ADDENDUM NO. 2

June 27, 2022

Additions and Renovations to Edgewood Intermediate School
7620 E Edgewood Ave.
Indianapolis, IN, 46239

Addendum Two (AD.02) to the drawings and specifications prepared by Gibraltar Design and The Skillman Corporation for **Edgewood Intermediate School Additions and Renovations** for Franklin Township Community School Corporation, Indianapolis, Indiana.

© GIBRALTAR DESIGN SHEET
A-911

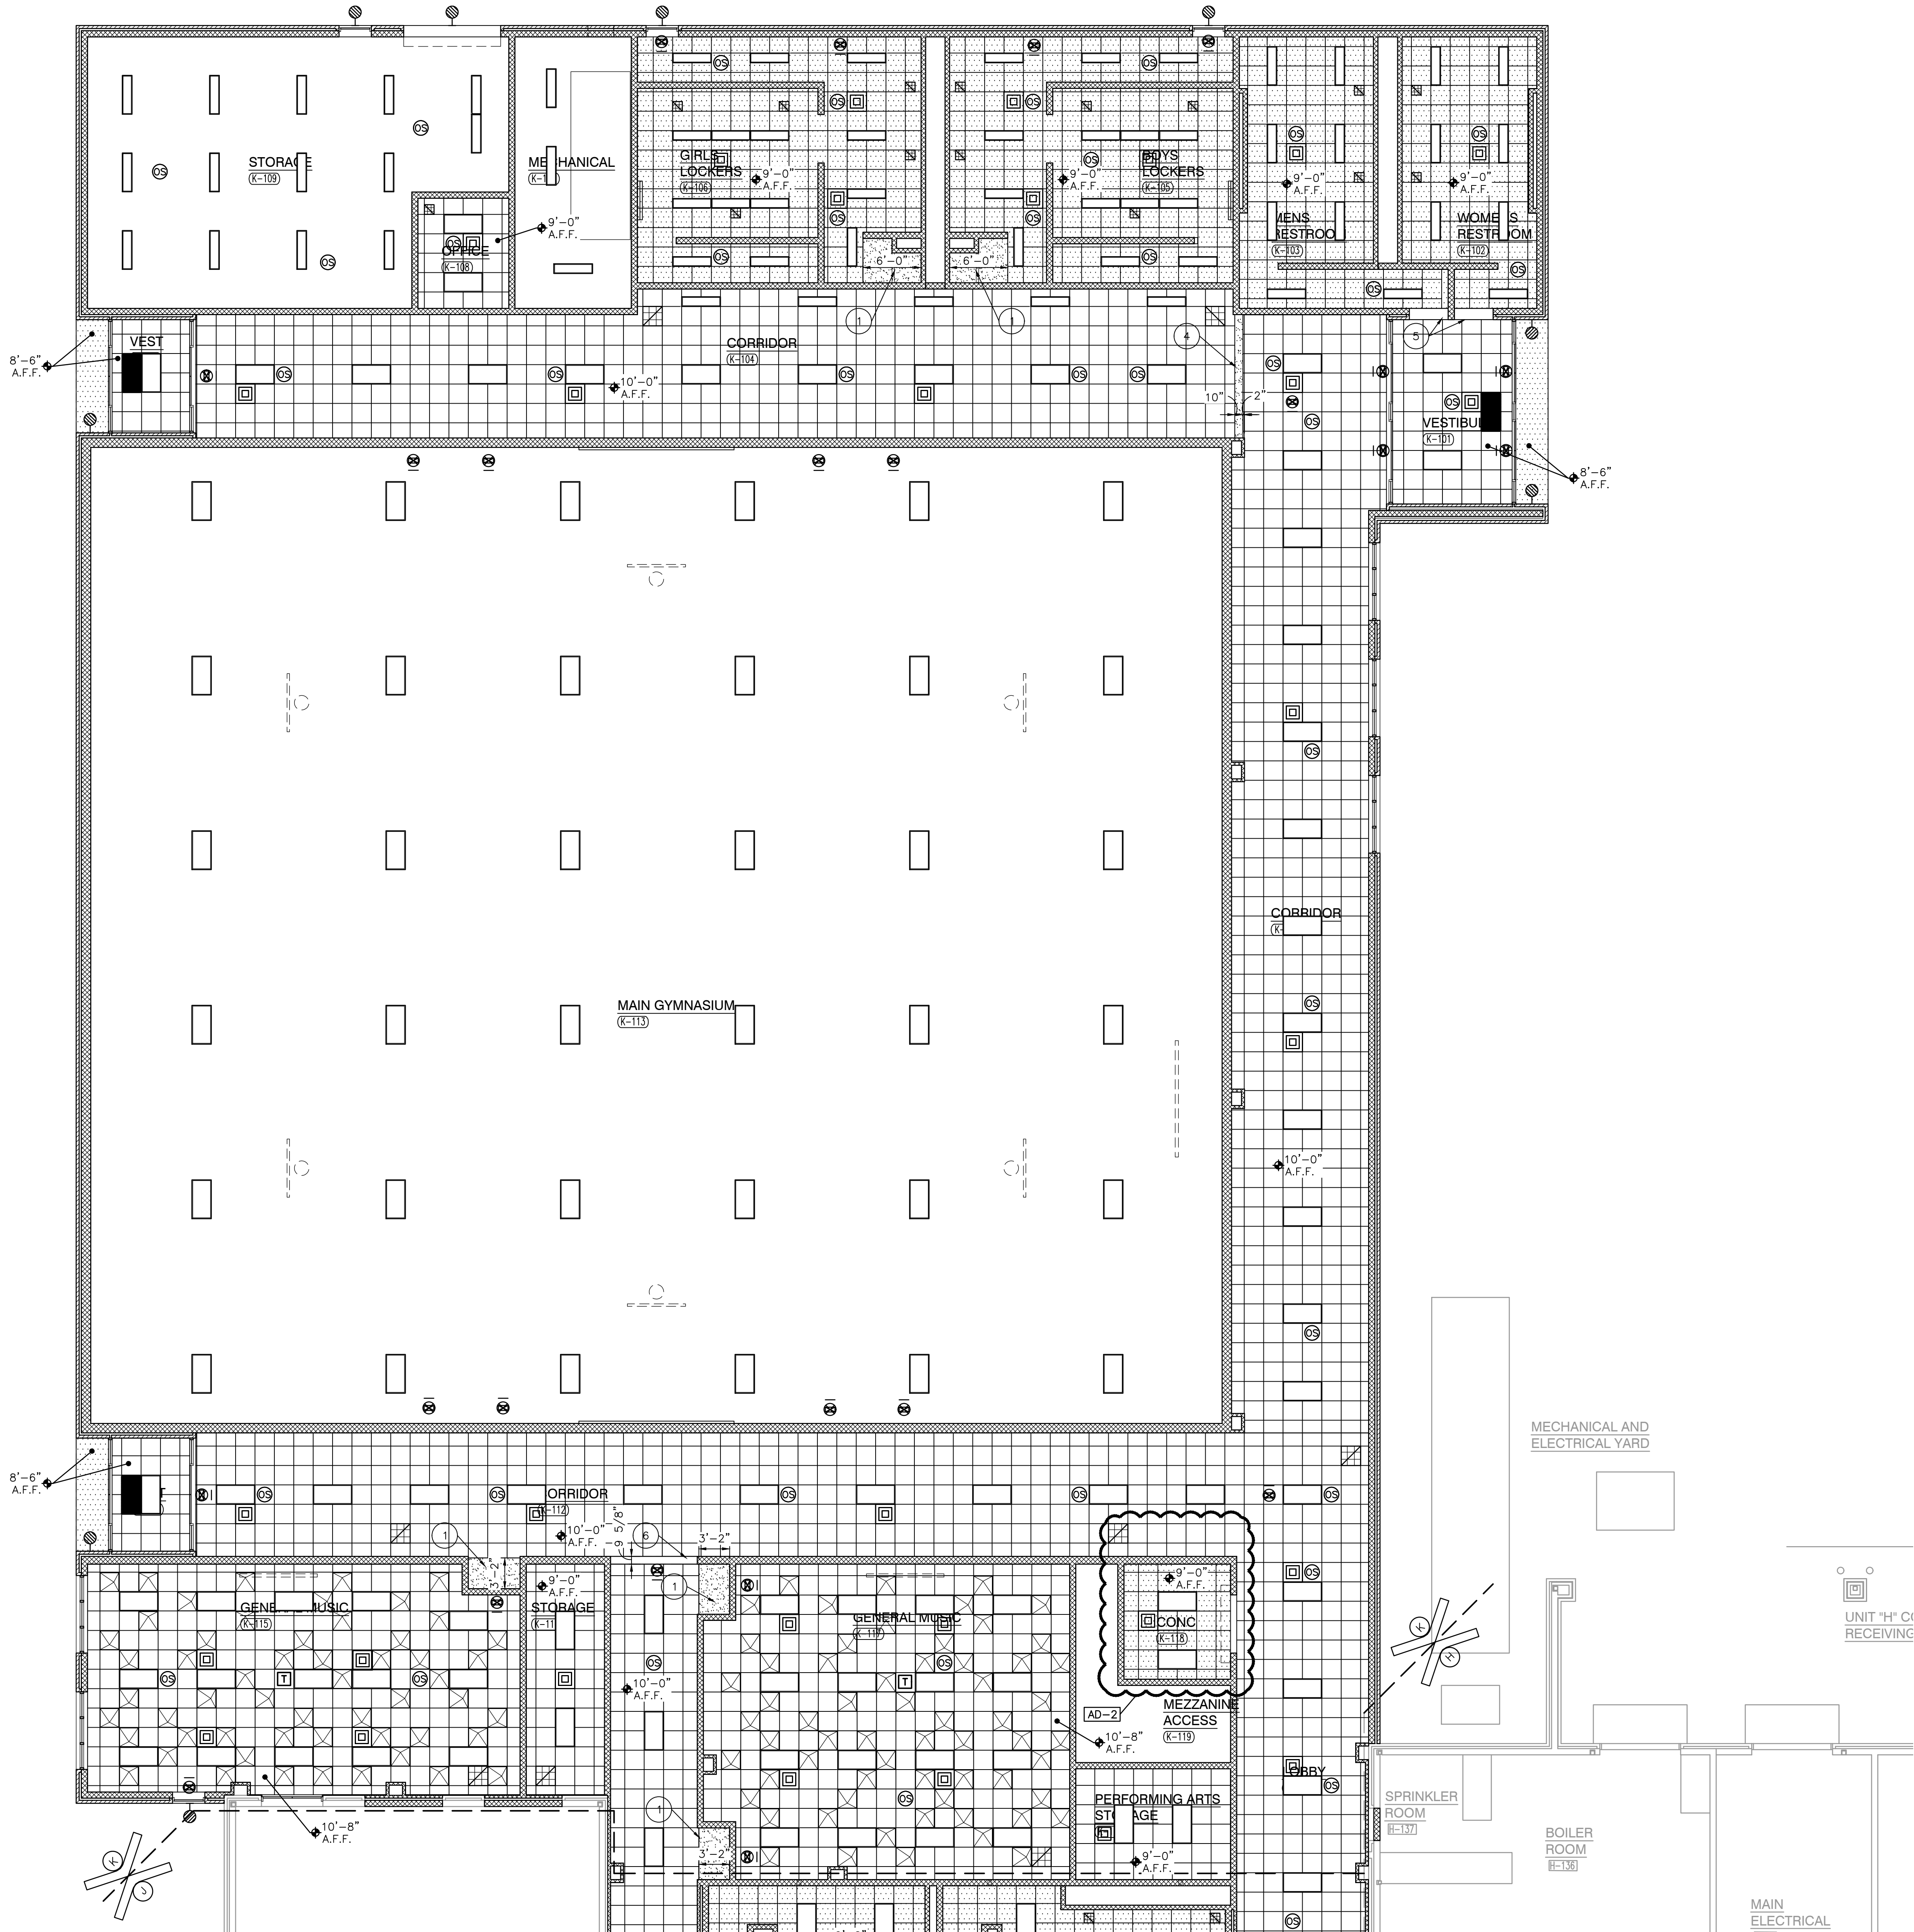
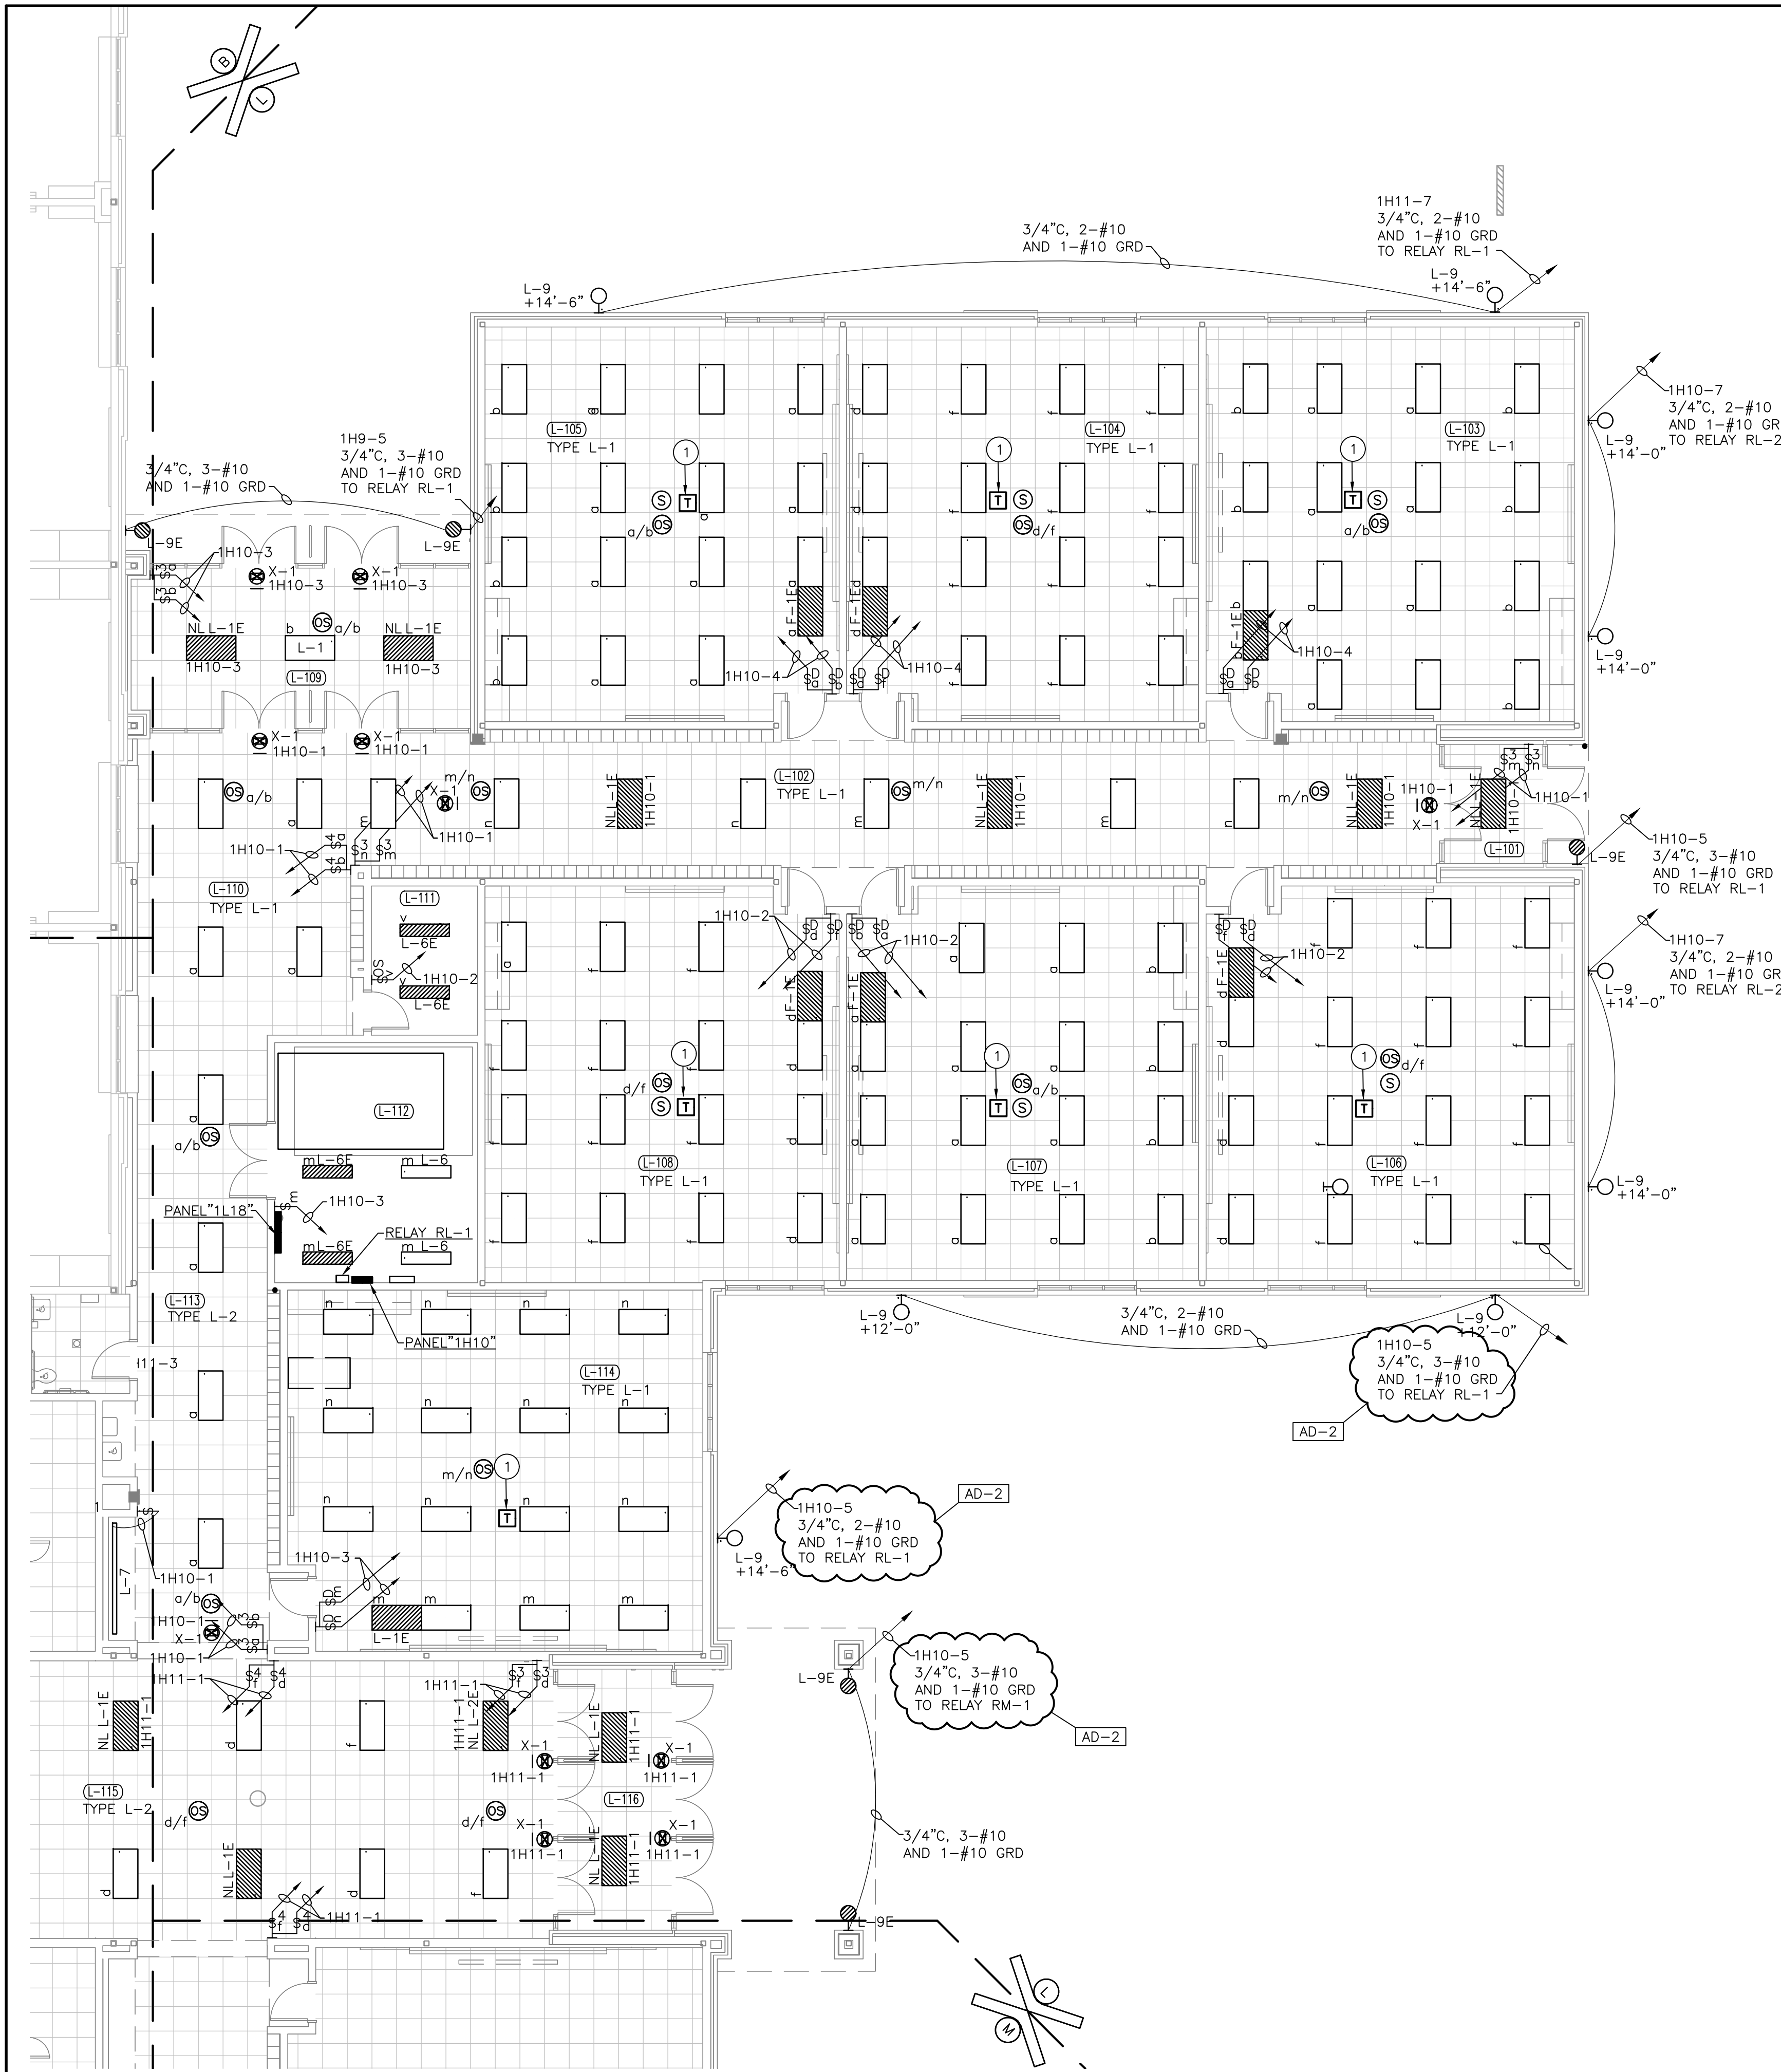
- A. Refer to two (2) revised, full-size drawings, included in this Addendum, for revisions.
